INVITATION TO TENDER "ITT" PS20201112
CONTRACTOR FOR ANDERSON STREET UTILITY UPGRADE

ADDENDUM NO. 6

RE: REPLACE DRAWINGS

PROJECT
CITY OF VANCOUVER
ANDERSON STREET UTILITY UPGRADES

millimeters plotted at ANSI D size

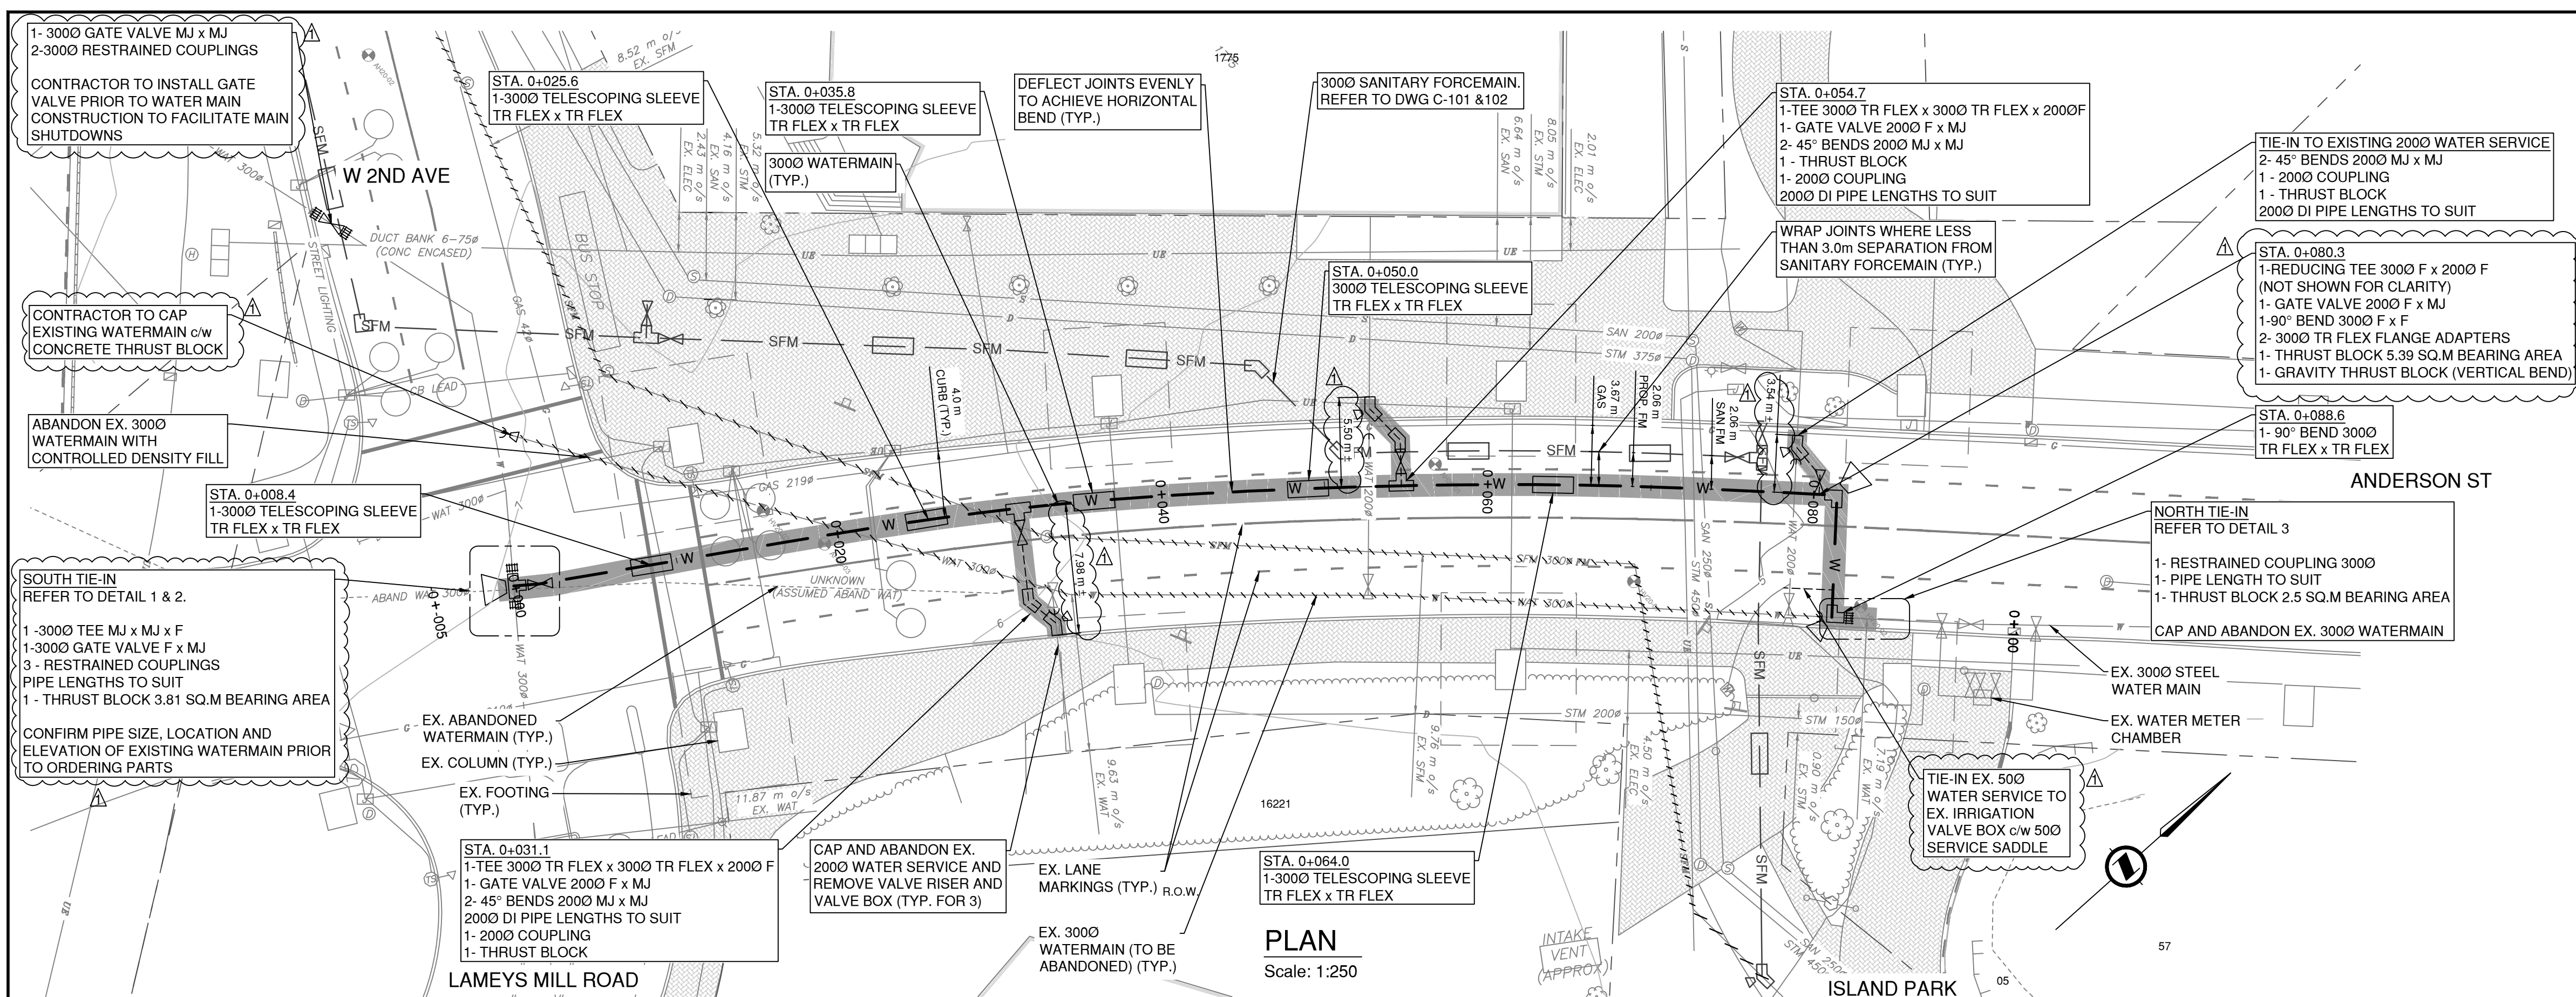
REV	BY	DATE	DESCRIPTION	DES	CHK
0	SP	14 OCT 2020	ISSUED FOR TENDER	SF	AB
1	SF	06 NOV 2020	GENERAL REVISIONS	SF	-

TITLE TYPICAL DETAILS

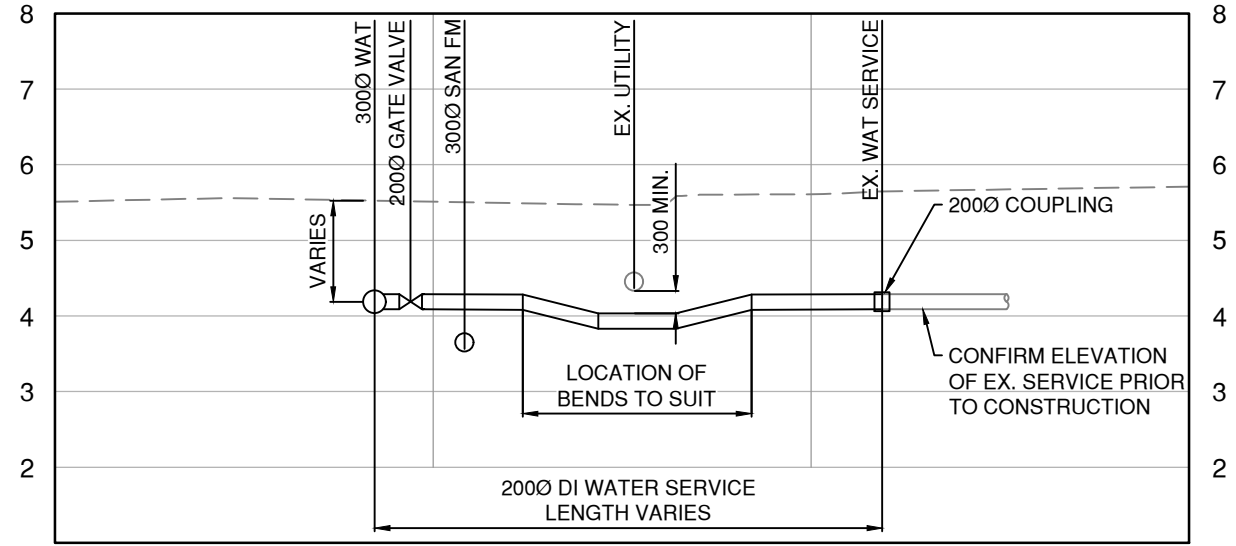
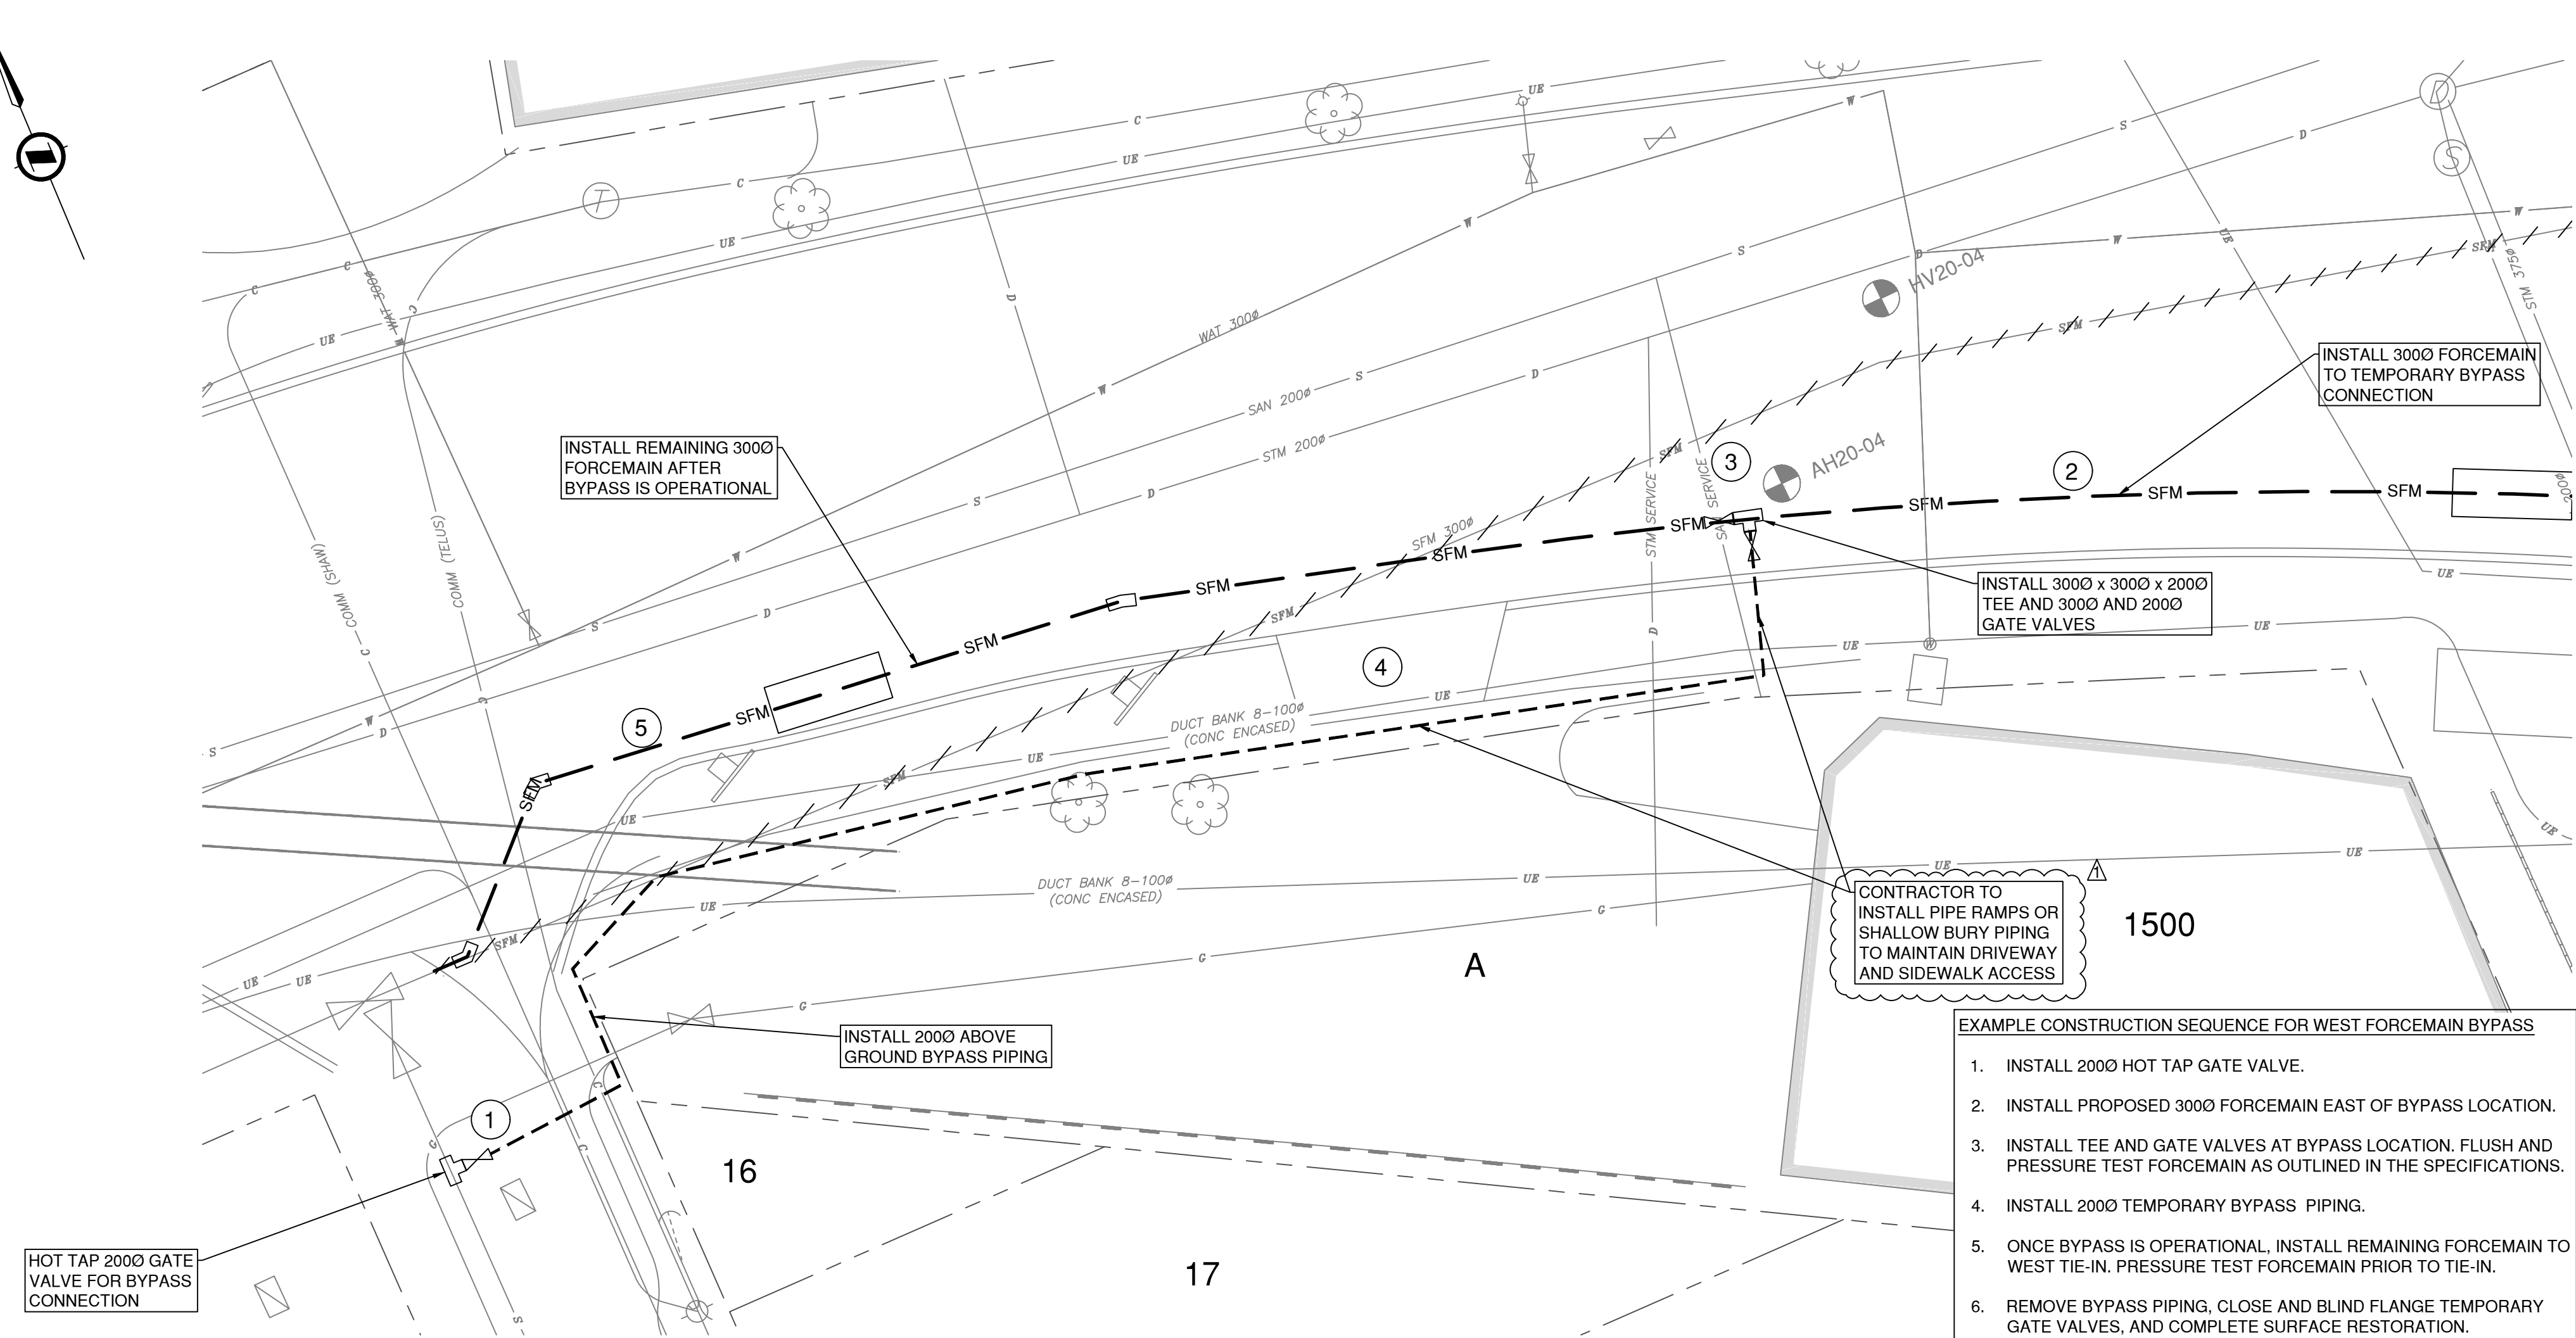
REV	BY	DATE	DESCRIPTION	DES	CHK
0	SP	14 OCT 2020	ISSUED FOR TENDER	SF	AB
1	SF	13 NOV 2020	TRENCH SECTION REVISED	SF	-
